**Millstone Power Station
Cooling-Water System Technology Study
Winter Flounder Mass-Balance Model - Review by ESSA Technologies Ltd.**

Enclosure 1 to Letter No. D17404

DOMINION NUCLEAR CONNECTICUT, INC.
MILLSTONE POWER STATION
NPDES PERMIT No. CT0003263

DNC Comments on the Review of the Millstone Power Station Larval Winter Flounder Mass-Balance Model Performed by Greig et al. (2002)

Fig. 1. Comparison of estimated CMR of Niantic River larval winter flounder from entrainment at MPS as given in DNC (2001b: Table 39, pp. 255-256) with a revised calculation based on increasing egg survival from 20% to 50% during the years 1995 through 2001.

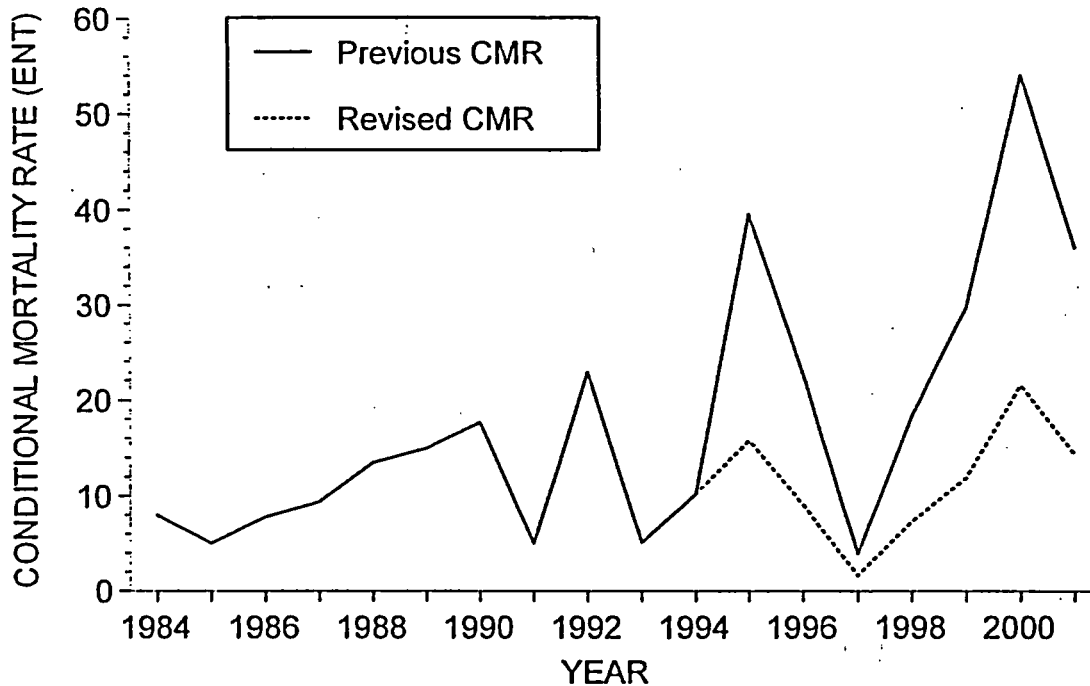
Section 2.2, Subsection 2.2.1 - Page 4, Paragraphs 1 through 3 - The trend in ENT (production loss or CMR, which is used by Greig et al. 2002) and the "puzzling" fact noted by Greig et al. (2002) that larval abundance has not declined in a fashion consistent with low adult spawner abundance can be explained if the compensatory decline in egg mortality hypothesis is real. The data leading to this conclusion are found in DNC (2002b: Table 39, pp. 255-256) and shown graphically by Greig et al. (2002: Fig. 1, p. 5), which shows a recent increase in annual estimates of CMR. Also, the estimated 82.2-89.6 million larvae assigned to the Niantic River by the MBM in the last 2 years (DNC 2002b: Table 39, pp. 255-256; corrected for Stage 1 entrainment) appeared to be at odds with the low adult population size and egg production estimates. These observations are consistent with density-dependent theory (e.g., Hilborn and Walters 1992) in that less egg deposition results in lower egg mortality, likely from predation, and thus, a higher hatching rate that results in more Stage 1 larvae. The relatively large number of larvae available for entrainment in 2000 and 2001 were also probably a result of the very low larval mortality rates in those years (DNC 2002b: Table 15, p. 204), leading to high densities in Niantic Bay (DNC 2002b: Table 15, p. 193). Low larval mortality, at least in 2001, likely was the reason for very high settling densities of demersal juveniles that year (DNC 2002b: Fig. 26, p. 207). As for the trend in ENT, the higher than average CMRs seen since 1995 coincide with the higher (except for 2000) than expected numbers of Stage 1 larvae observed in the Niantic River during the same years. Yet, in the calculation of production loss, unlike the calculated annual stage-specific larval mortality rates, the egg mortality rate ($M_{egg} = 1.61$, equivalent to a survival rate of 20%) has not been varied by year. This makes the calculation of Niantic River stage-specific abundance (the denominator in the production loss calculation) lower than it should be if egg mortality rates were reduced under low adult spawning stock sizes. As noted in DNC (2002b: p. 254), this would make the calculation of production loss conservatively high, perhaps by a factor of 4 or more. However, if the annual egg survival rate for the years 1995-2001 is increased somewhat arbitrarily from 20 to 50%, which is a reasonable assumption, then the CMR time-series resembles historical rates (Fig. 1), fluctuating around a revised geometric mean value of 9.6%.

Fig. 2. Numbers of entrained winter flounder larvae attributed to the Niantic River as determined by DNA analysis (solid line) and the MBM (dashed line) in 2001 and 2002.

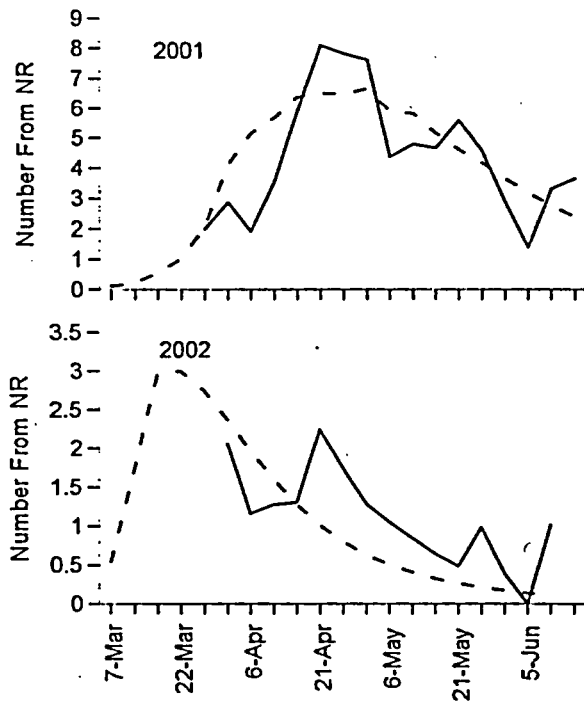
Section 6.2, Page 51, Text Paragraph 3 - Greig et al. (2002) note the possibility of using DNA or microelement typing to assess the relative contribution of larvae from different stocks of winter flounder at NB. We do not believe that this effort is warranted. The direct measure of larval stock identification at the MPS is preferable to measuring the components at NB to verify the indirect estimates of entrainment made using the MBM. We were puzzled why the DNA analysis of larvae entrained at MPS performed by Dr. Joseph Crivello of the University of Connecticut was not mentioned in Greig et al. (2002). This work provided a direct estimate of the fractions of larval winter flounder entrainment at MPS attributed to the Niantic River spawning stock and stocks located in the Thames River and just west of the Connecticut River. The report of Crivello (2002) was sent to DEP via DNC (2002a) and to both DEP and ESSA by DNC (2002c). The latter submission also included pages 251-254 of DNC (2002b), where the findings of the Crivello (2002) DNA analysis for 2001 samples (1,067 entrained larvae) were compared to MBM results. This comparison (DNC 2002b: Table 38, p. 253) showed that the fractions of larvae attributed to the Niantic River were virtually identical from DNA analysis (22%) and the MBM (21.4%). Certainly, there was some variation in timing of Niantic River larval entrainment between the two methodologies (see DNC 2002b: Fig. 45, p. 254), possibly related to the point samples taken for DNA analysis and the relatively smooth curve generated by the MBM. However, the highly similar end results lend much credibility to the MBM.
